# UNITED STATES PATENT AND TRADEMARK OFFICE

APPLICATION NO.	FILING DATE	FIRST NAMED INVENTOR	ATTORNEY DOCKET NO.	CONFIRMATION NO.
10/619,648	07/14/2003	Steven Robert Hetzler	ARC920030040US1	8642
55508	7590	06/02/2006	EXAMINER	
JOSEPH P. CURTIN, L.L.C. 1469 N.W. MORGAN LANE PORTLAND, OR 97229-5291			CHAUDRY, MUJTABA M	
			ART UNIT	PAPER NUMBER
			2133

<b>Office Action Summary</b>	<b>Application No.</b> 10/619,648	<b>Applicant(s)</b> HETZLER ET AL.	
	<b>Examiner</b> Mujtaba K. Chaudry	<b>Art Unit</b> 2133

FIG. 1

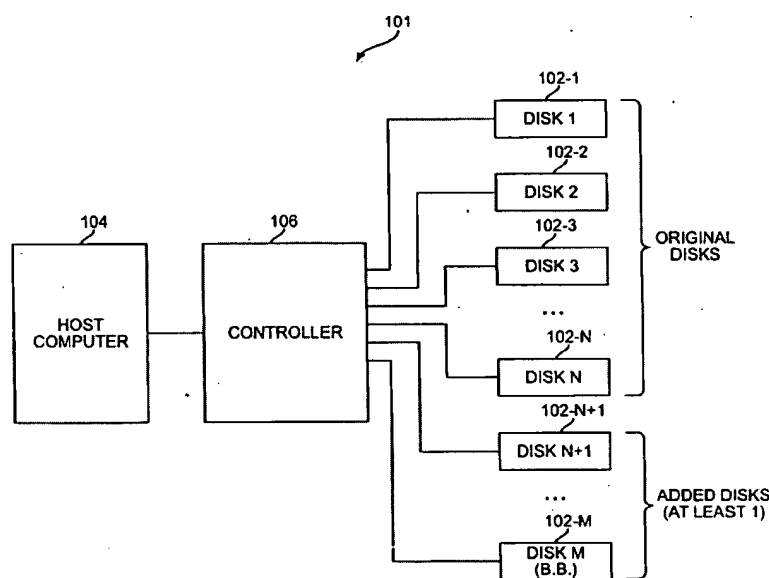
destination storage devices; repeating the steps of migrating, copying, and mirroring, until data that will be in the destructive zone is migrated out of the destructive zone; and migrating remaining data from the source disks onto the destination disk. Particularly, King teaches Figure 1 an array controller 106, a plurality of original disks N (analogous to data storage units) and a plurality of added disks M (analogous to check storage units).

King does not explicitly teach to have three storage units and three check units as stated in the present application.

However, the Examiner would like to point out that have exactly three storage units and three corresponding check units is a matter of obvious engineering design choice. Therefore it would have been obvious to limit the number of storage units and number of corresponding check units in King to three as is suggested in the present application. This would have been obvious since three is a number, which is included in a plurality as is taught by King. Further
